Transportation Master Plan (Mobility CC) Amendments

Planning Commission – January 21, 2026

DEVELOPER REQUEST

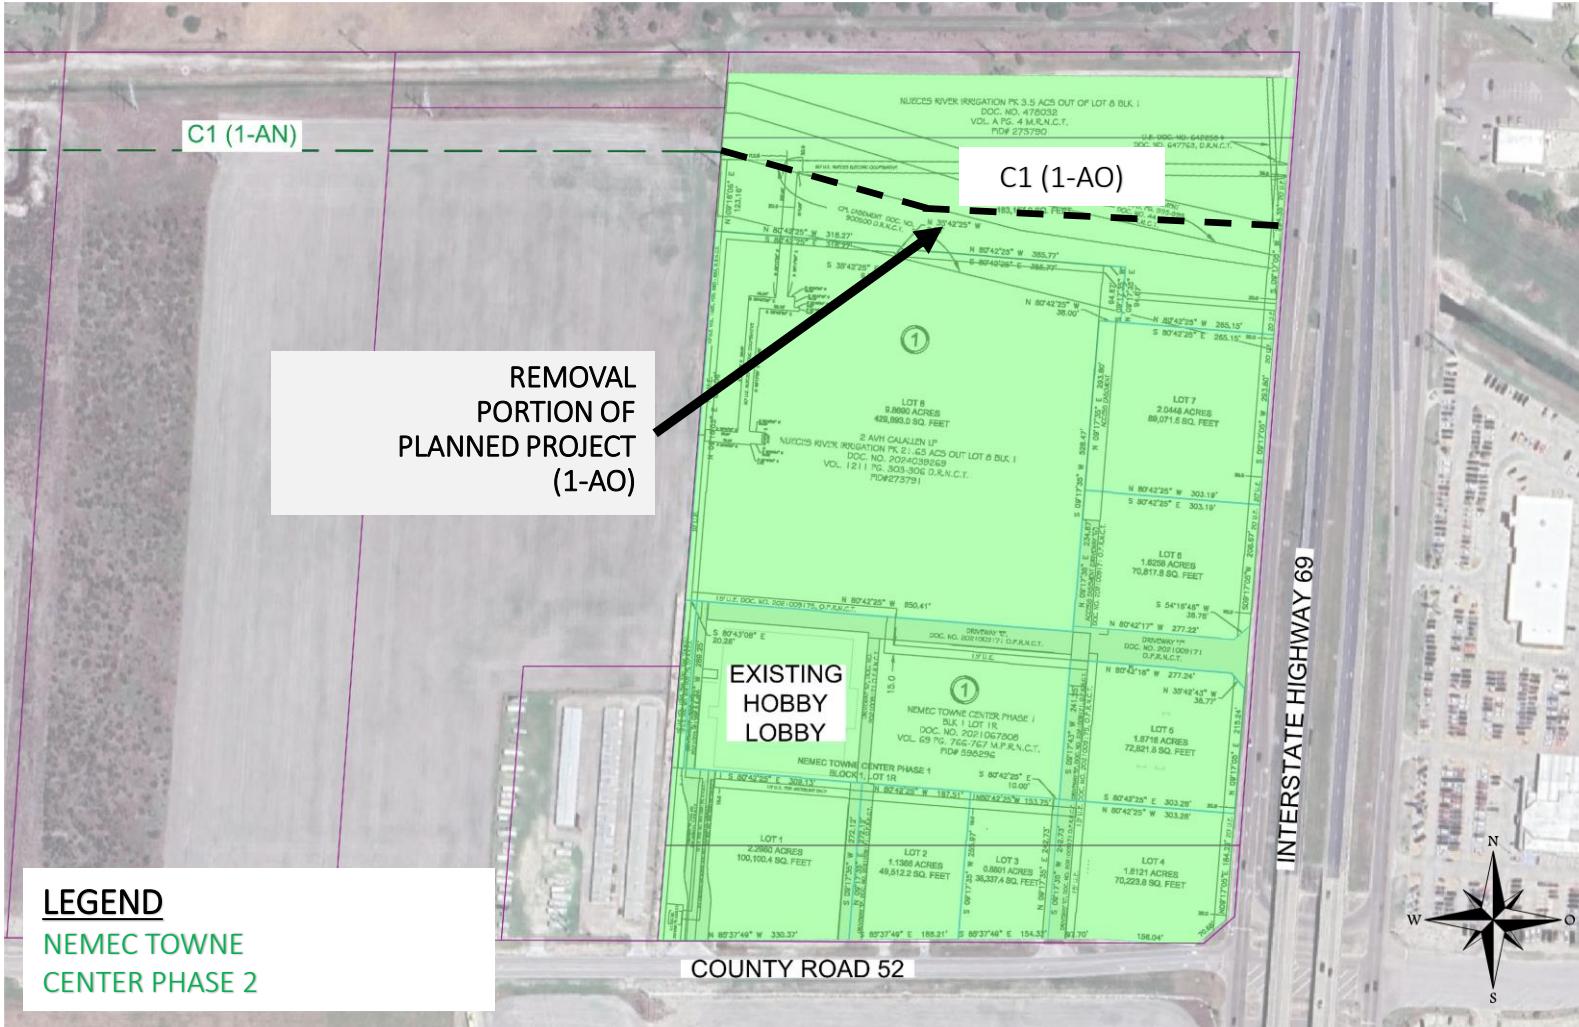
Development	RMP	Classification	Limits	Developer Request
	Project #			
Nemec Towne Center Ph2	1-AO	Proposed C1 Collector	3105' E of CR69 to 4519' E of CR69	Deletion
Meadow Ridge	1-AN	Proposed C1 Collector	1400' E of CR69 to 3105' E of CR69	Deletion
Meadow Ridge	1-AO	Proposed C1 Collector	3105' E of CR69 to 4519' E of CR69	Deletion

PW STAFF RECOMMENDATION

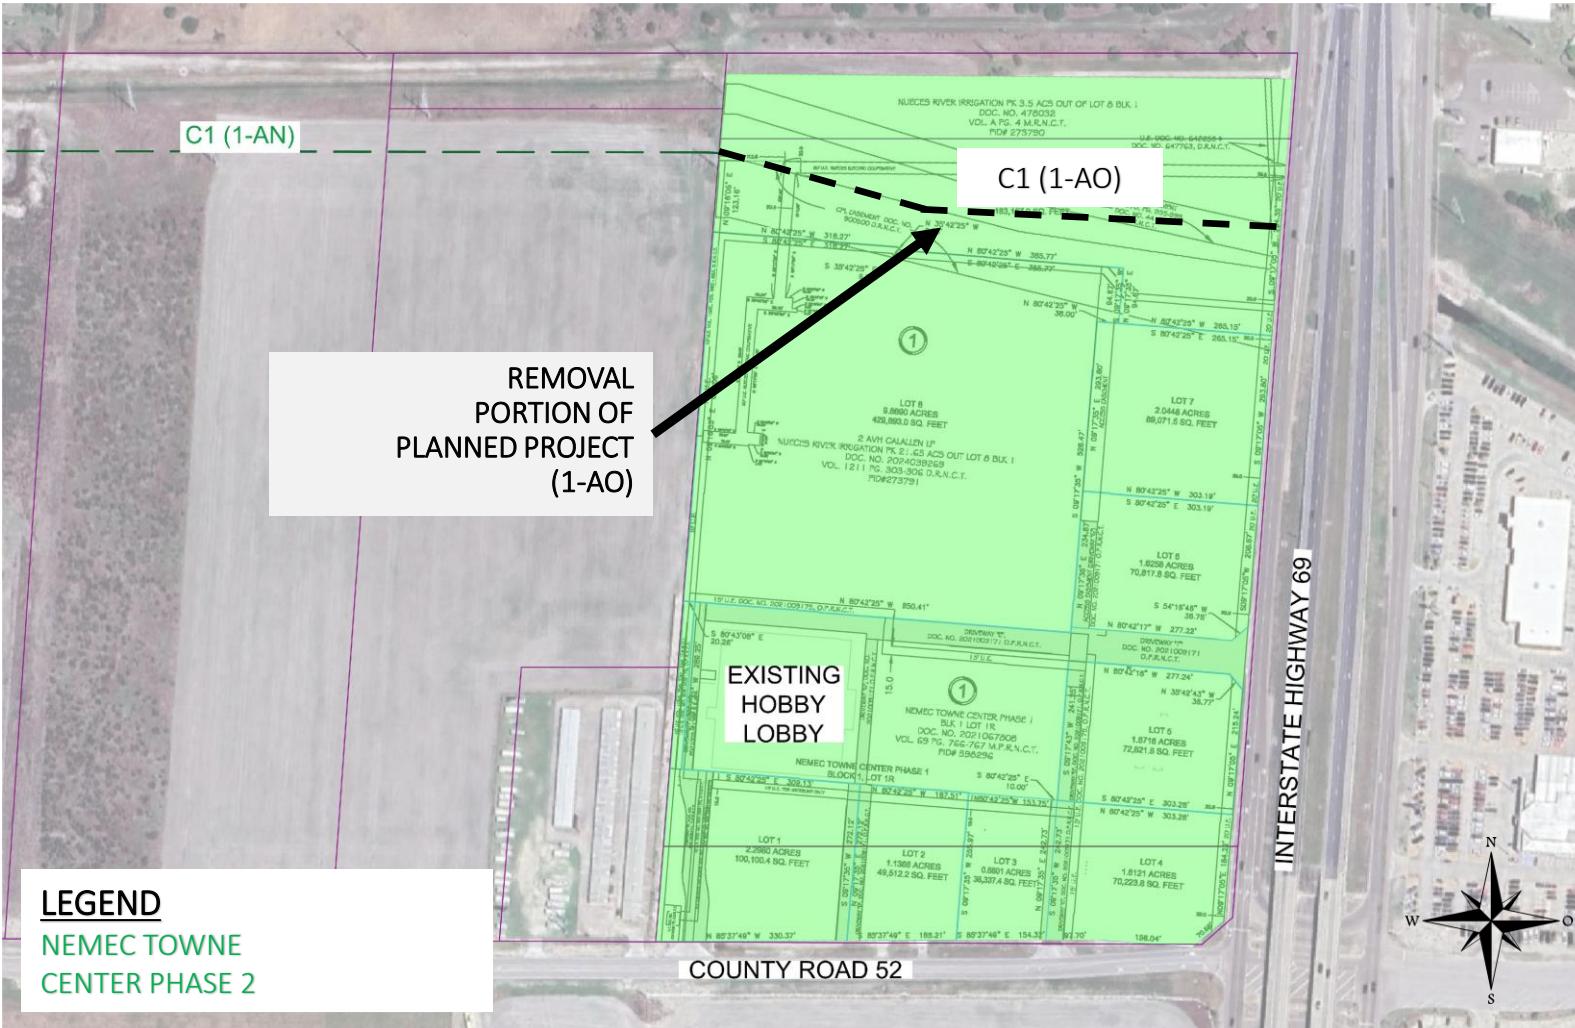
- Delete Project 1-AO from Master Plan.
- Maintain Project 1-AN on the Master Plan.
- Maintain Project 1-AO within boundary of Meadow Ridge subdivision.
 - Maintains required access points for subdivisions with >81 lots (Per *UDC Section 8.2.1.D. External Connectivity*).
 - Maintains Fire Code requirements for two external access points for public safety.
 - Maintains west connectivity per the Master Plan.

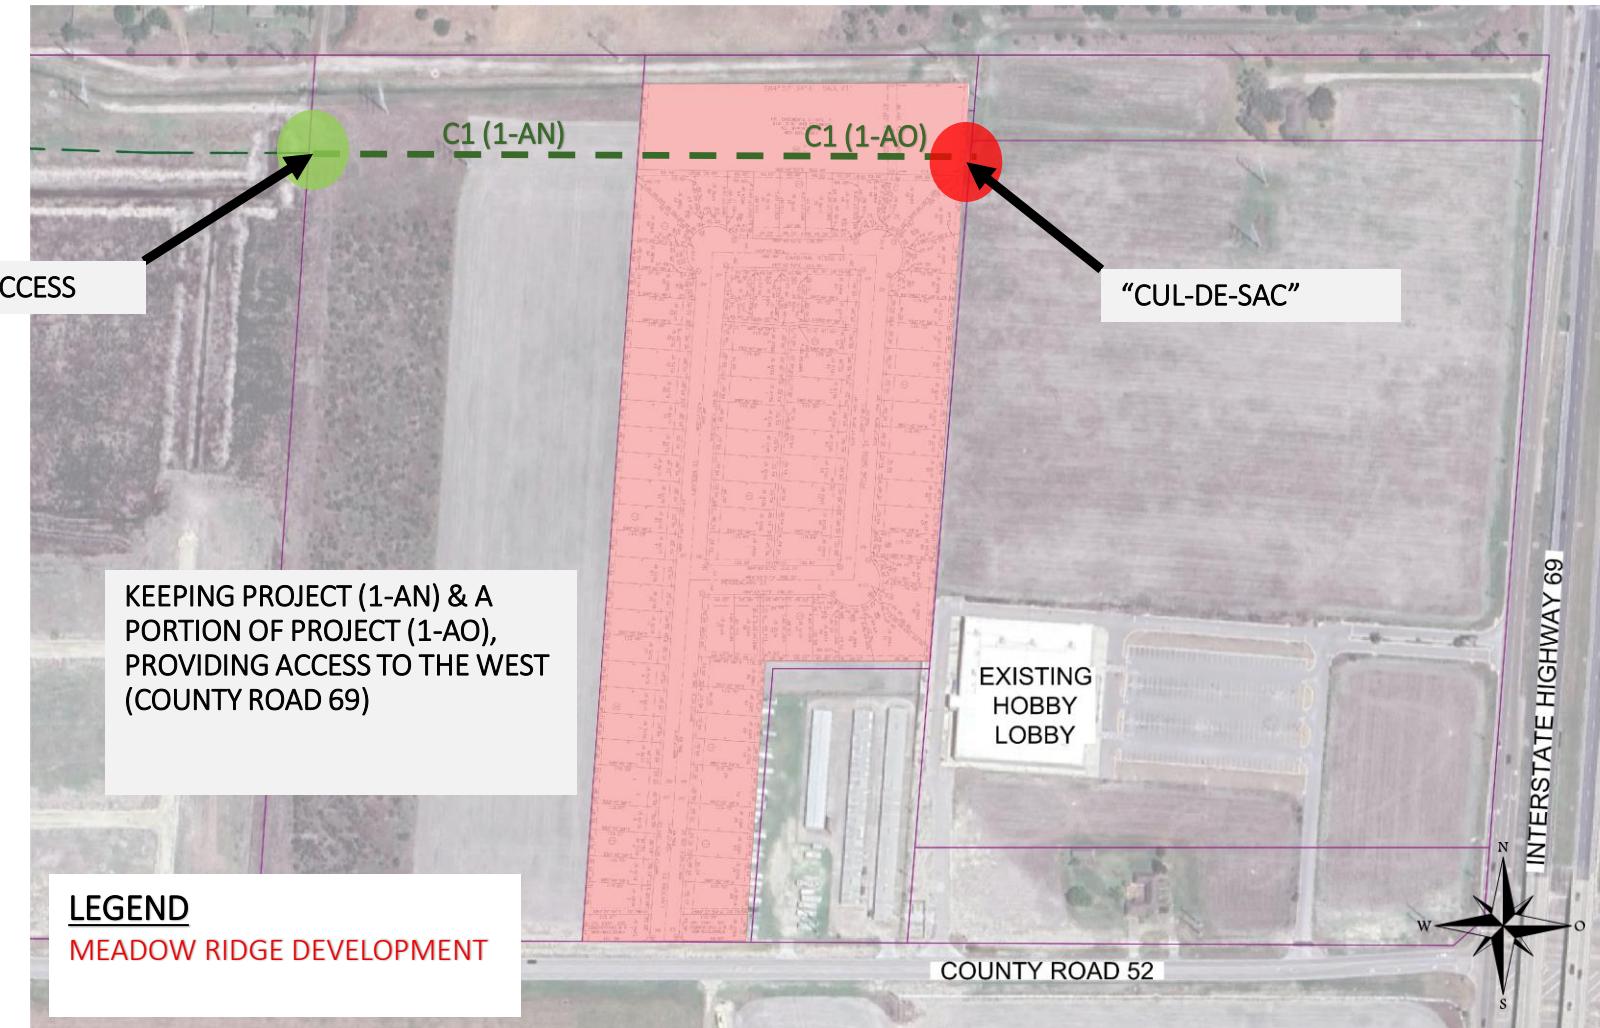
Unless otherwise approved by the Fire Marshal. 14cc Note: This plan review indicates that 89 homes will be constructed.

Therefore, per the directives above, two points of access will be required from CR 52. Please submit revised plans indicating these two points of access.
